CASE'S INTERROGATORIES TO APPLICANTS AND REQUESTS TO PRODUCE

Regarding A500 Steel:

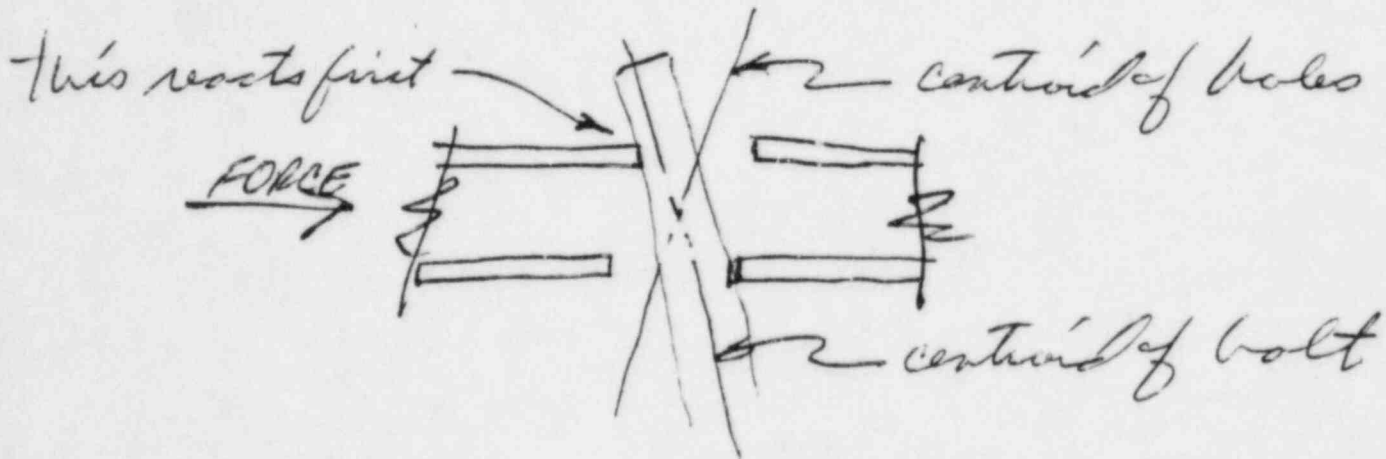
- c. (1) Did the analyses consider the variability of the tube steel material properties, length end conditions; i.e., welded plates, angularity of the rod and insert?
- (2) Isn't it true that the effect of the top of the tube would resist the load first, and then the bottom would resist, as demonstrated in the drawing below:
